Subject: Submittal to Docket NHTSA 2000 - 7013 - 53
of Ex Parte Information Received from Mitsubishi Motors

No: WF00-555 Subject: Follow up to FMVS 208 Workshop

**Mitsubishi Motors Petition for Reconsideration to Advanced Airbag Final Rule
Docket No. NHTSA 00-7013; Notice 1**

Position 2
(Preliminary Study)

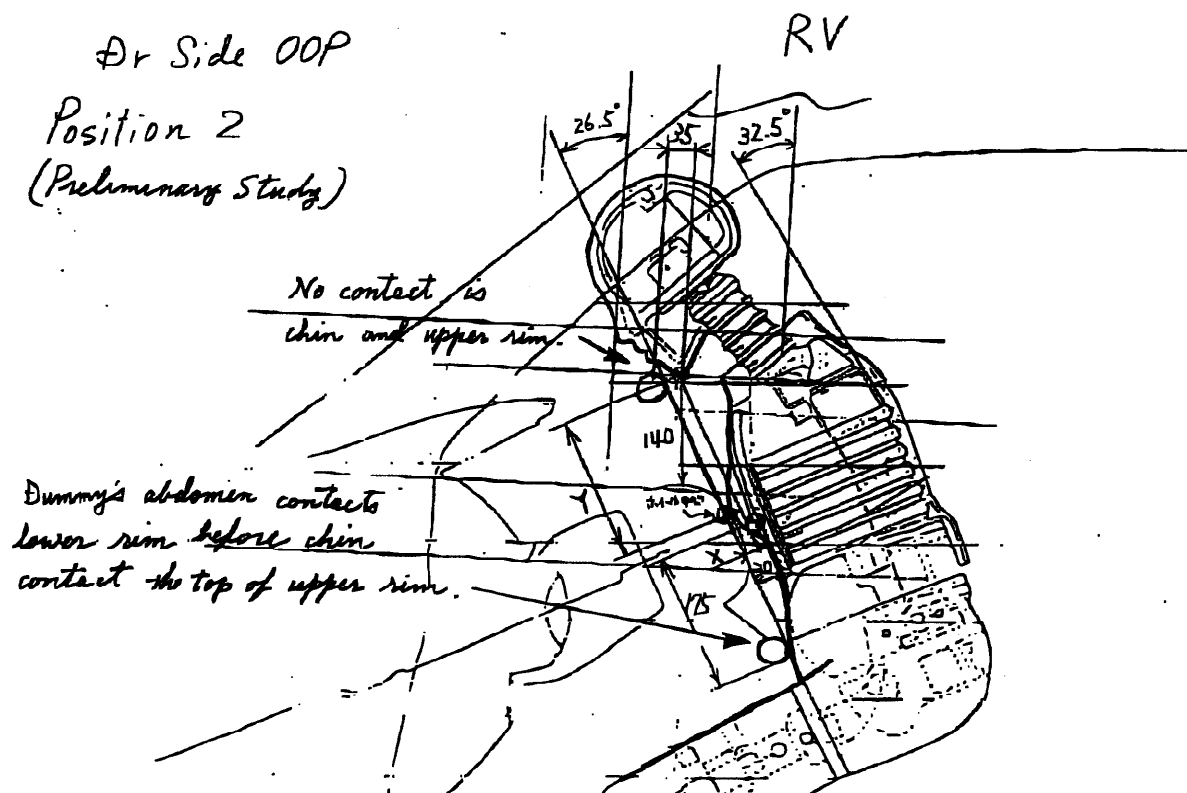
As the attached drawing shows, the AF5% dummy's abdomen contacts the lower portion of the steering wheel before the chin can be positioned on the upper portion of the steering wheel.

The position of the chin for the AF5 OOP Position-2 is set to the steering wheel rim and forward head movement is stopped only if there is contact with the windshield, but what should be done if the chest, torso, contact the steering wheel first? Mitsubishi Motors believes NHTSA should specify that dummy movement should be stopped if any part of the dummy comes into contact with the steering wheel before the chin can be positioned.
